Forsyth County Procurement

ADDENDUM #6

RFP 20-78-1620

For: Providing all labor, equipment and materials for the construction of a new Juvenile Justice Center at 875 Lanier 400 Parkway, Cumming, GA 30040. Project includes a multi-phased site development, demolition of existing motel structures and construction of new 62,000 square foot Juvenile Court building.

Sheet No.
P-1.01

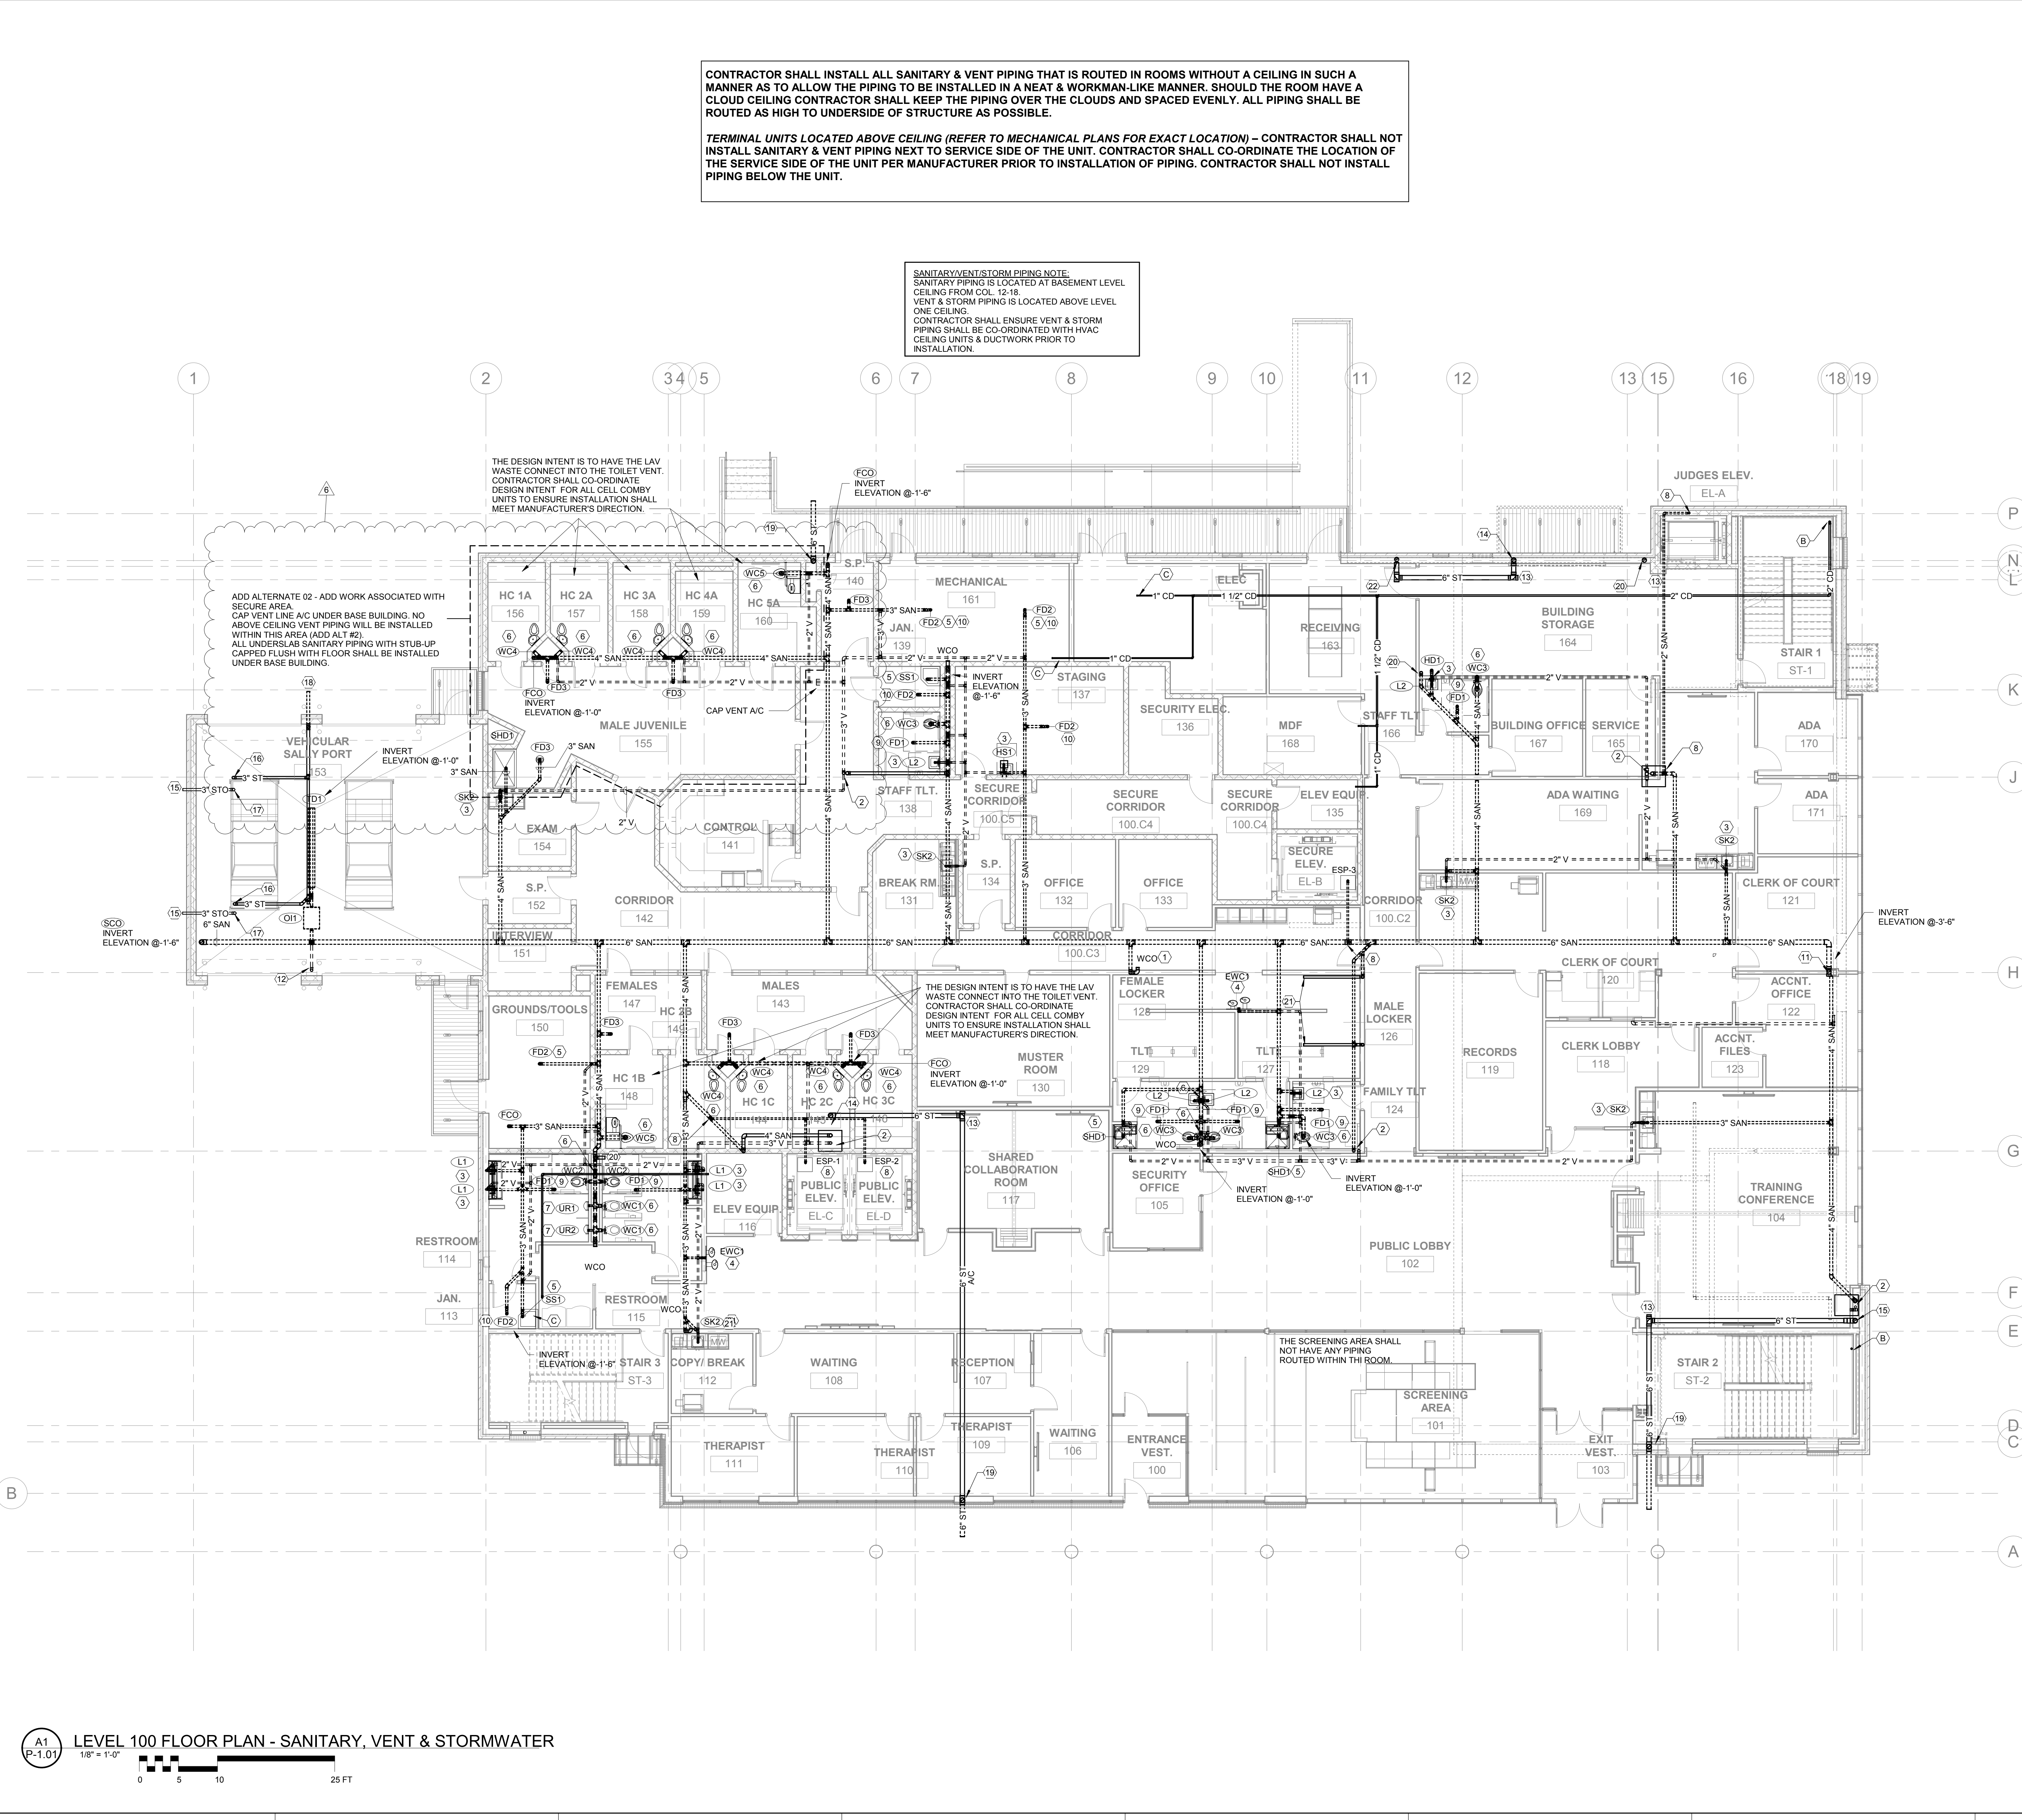
105. Detail A4/P-5.01 does not appear to match the routing for the elevator sump pump discharge (all). Please clarify.
- a. **RESPONSE: THE ELEVATOR DISCHARGE PIPING SHALL BE AS INDICATED ON P-1.01.**

1. Clarified scope for Add Alternate #2, to include capping vent piping and no vent pipes above ceiling within the area.
2. Reference sheet P-1.01 LEVEL 100 FLOOR PLAN – SANITARY & VENT revised under addendum #06 dated 07/16/2020.

A1 P-2.01 LEVEL 100 FLOOR PLAN - DOMESTIC WATER
1/8" = 1'-0"

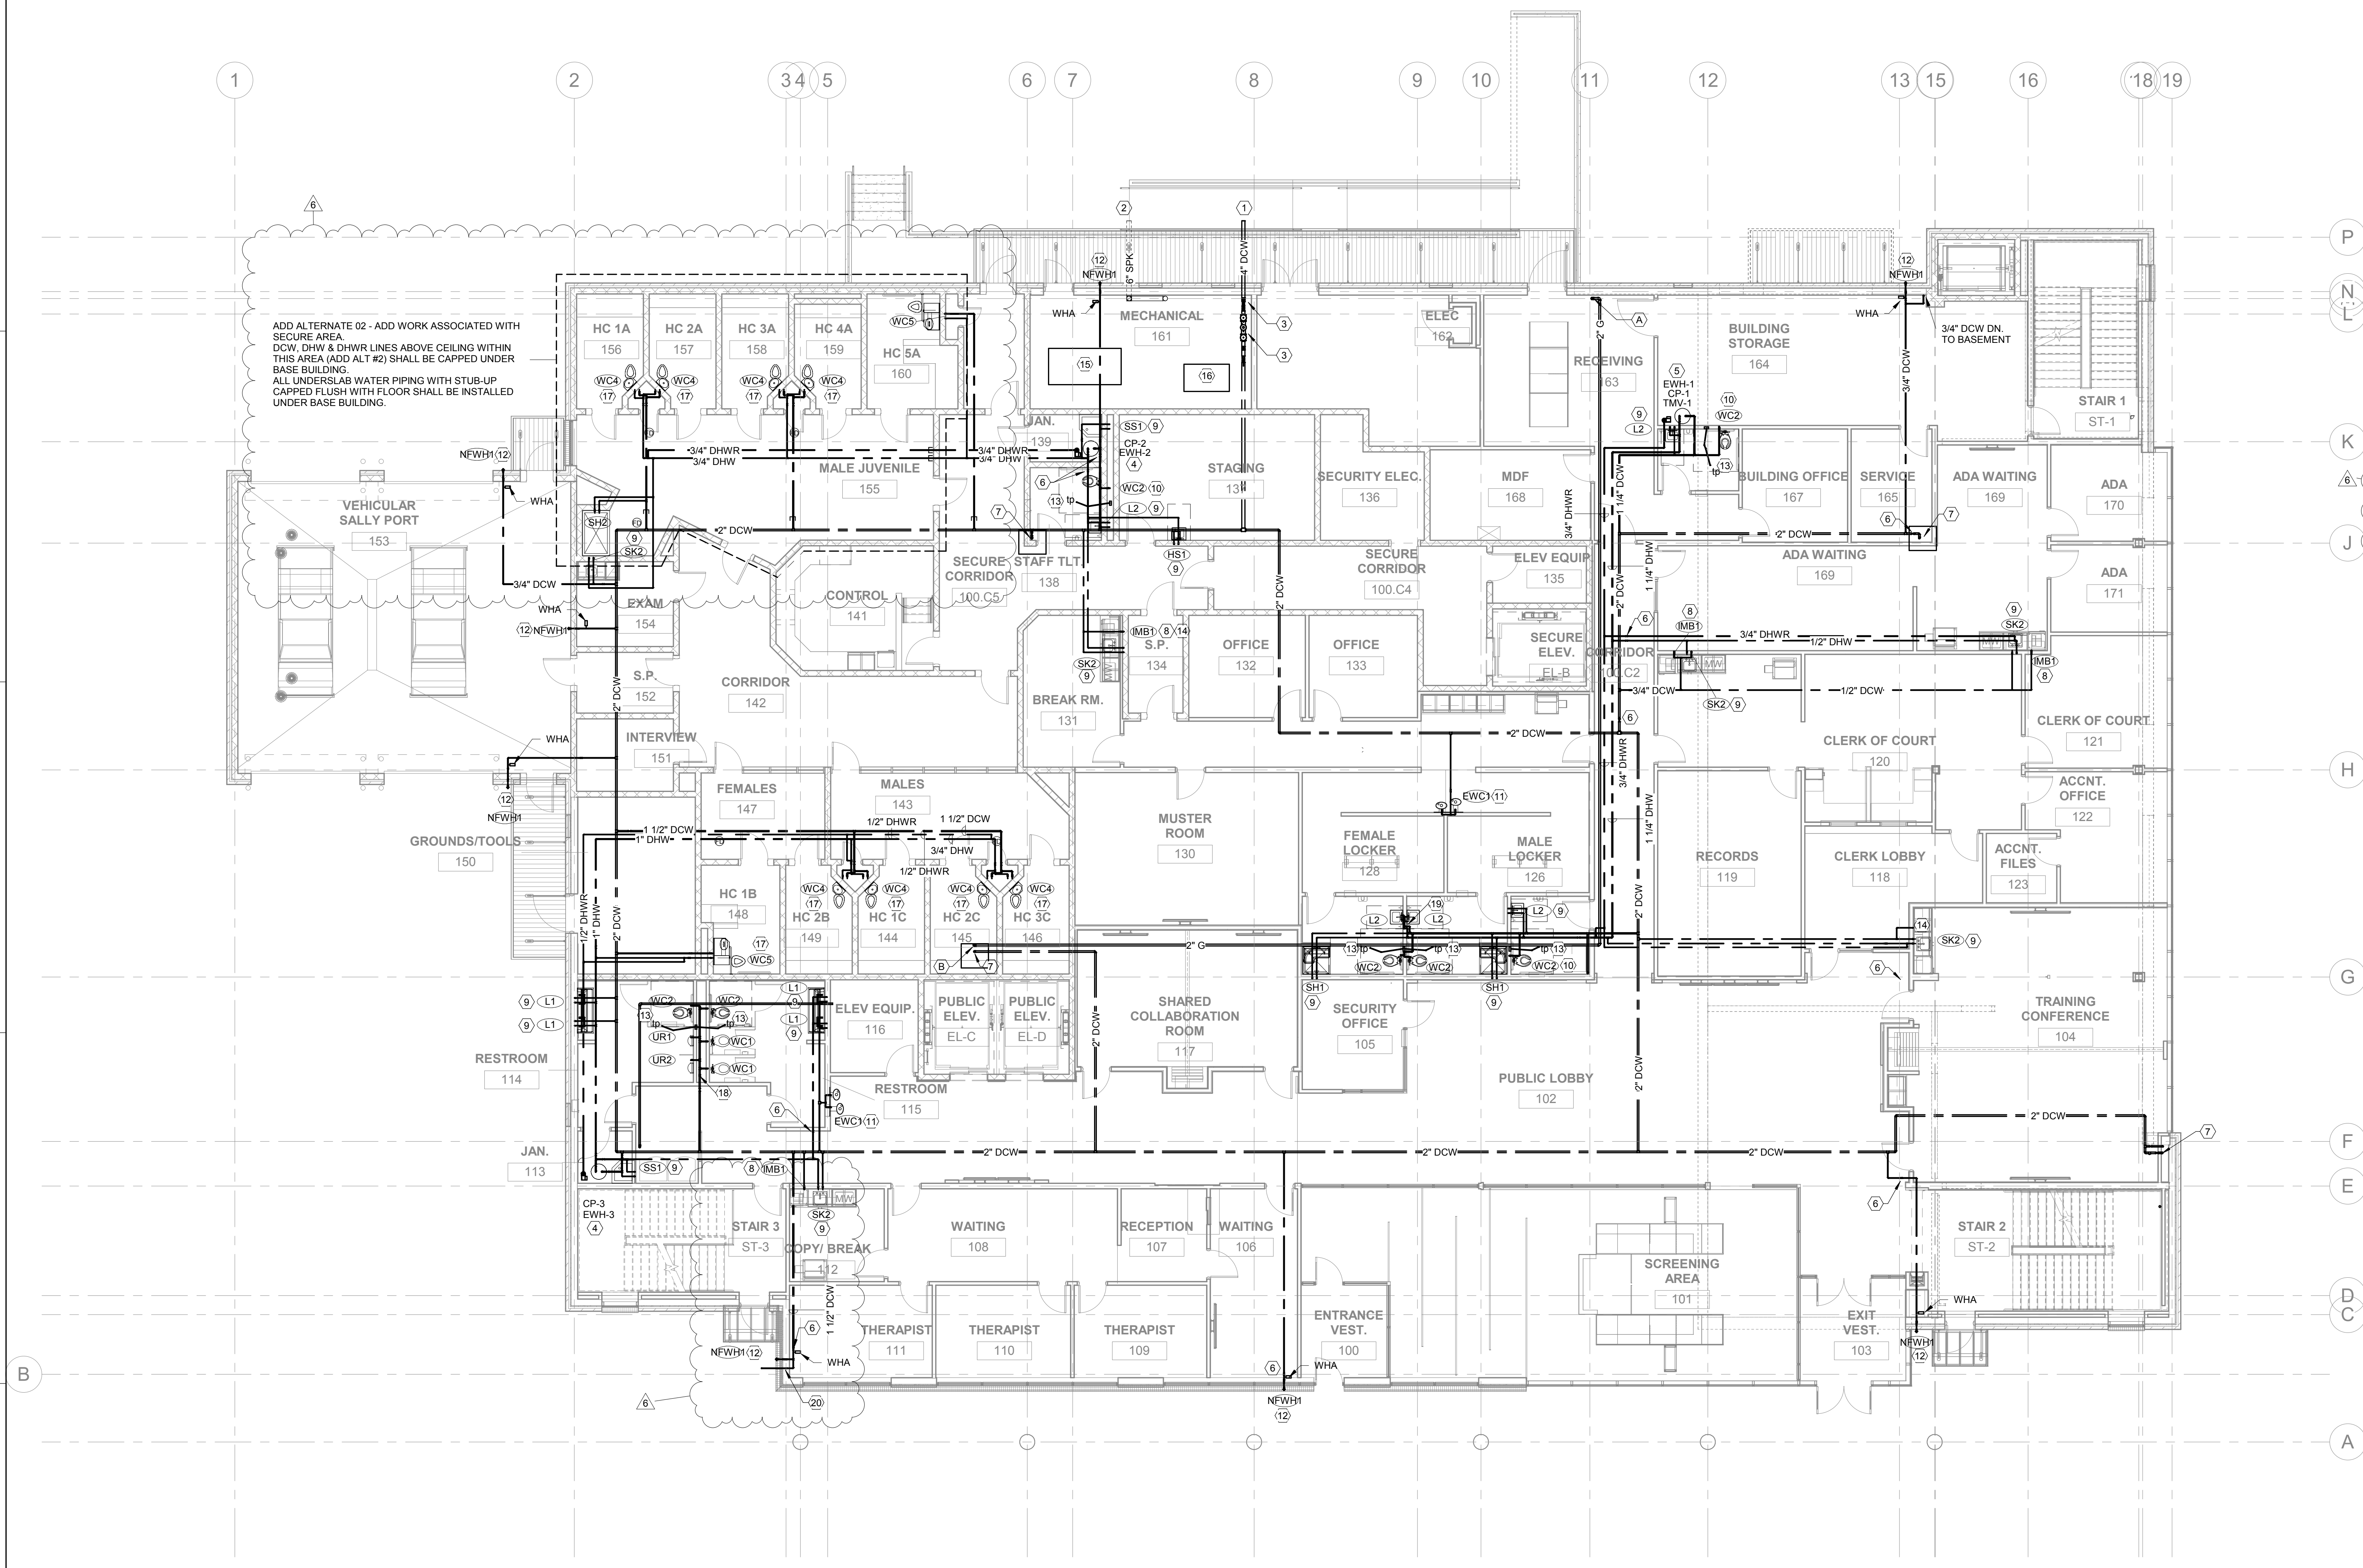
1. Clarified scope for Add Alternate #2, to include capping domestic cold water, domestic hot water & domestic hot water return lines above ceiling within the area.
2. Reference sheet P-2.01 LEVEL 100 FLOR PLAN – DOMESTIC WATER revised under addendum #06 dated 07/16/2020.

Sheet No. P-6.01
RELEASED FOR CONSTRUCTION

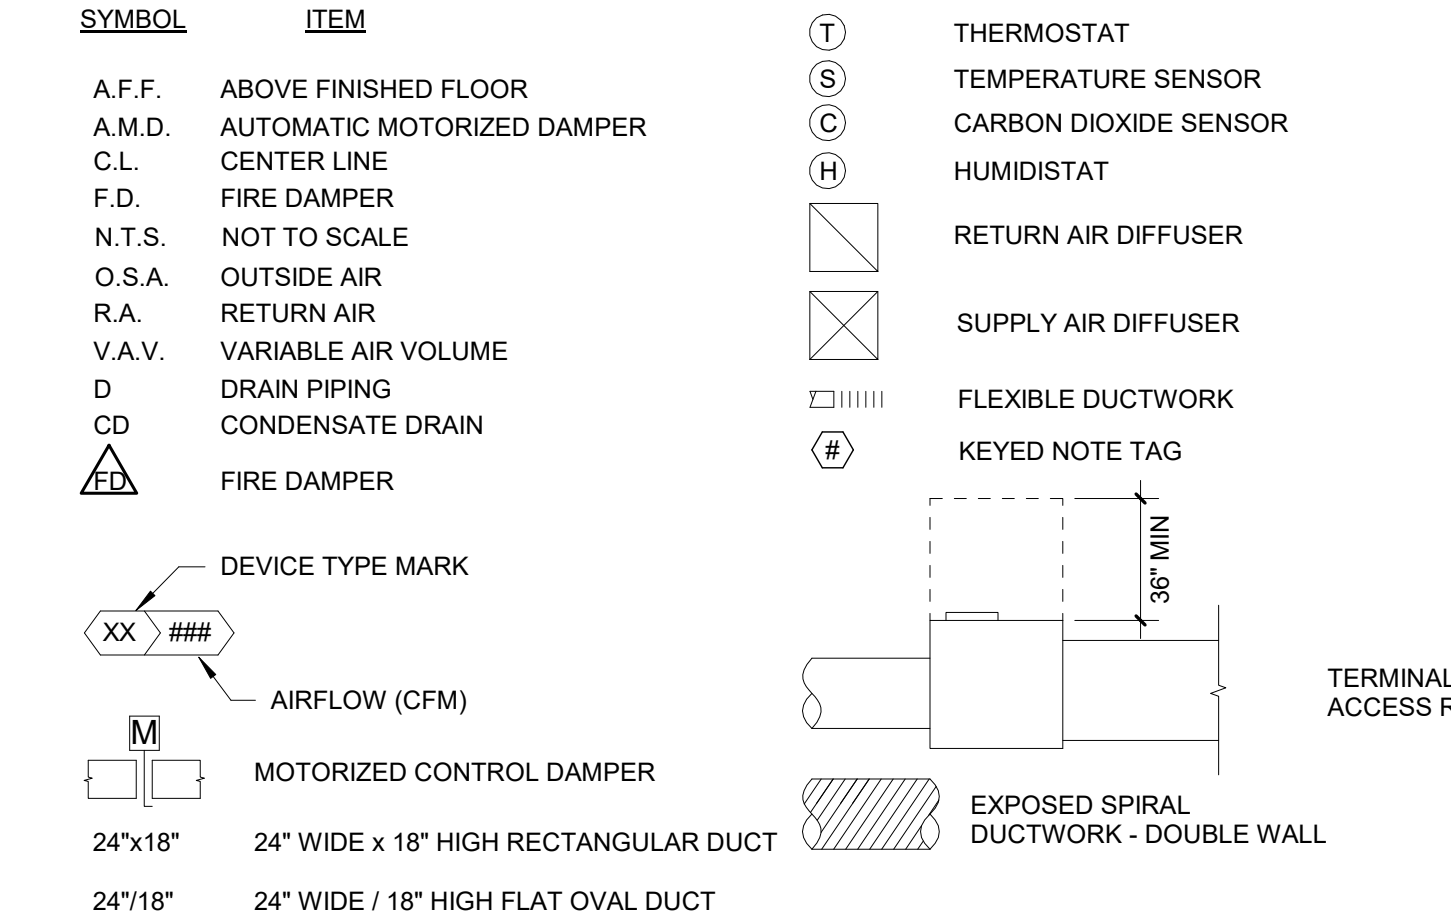
92. Per P1.00, what is OL1?
- a. **RESPONSE: JR SMITH 8550 - 50 GPM OIL INTERCEPTOR**
93. Help me understand the River Rock requirement. They are asking for quantity 861. Are they looking for tons or individual pieces?

- a. **RESPONSE: REPLACE ZURN Z-1388 NFRH1 TO WOODFORD MODEL SRH-MS THAT DOES NOT REQUIRE A DRAIN**
95. Where does the yard hydrant go?
- a. **RESPONSE: Sheet C122, note 4E indicates two (2) locations for yard hydrants. One at the dumpster and one in the landscape island near the building entrance**

1. Added Oil Interceptor (OI1) to schedule.
2. Revised Non-freeze roof hydrant specification from Zurn to Woodford.
3. Reference sheet P-6.01 PLUMBING SCHEDULES revised under addendum #06 dated 07/16/2020.
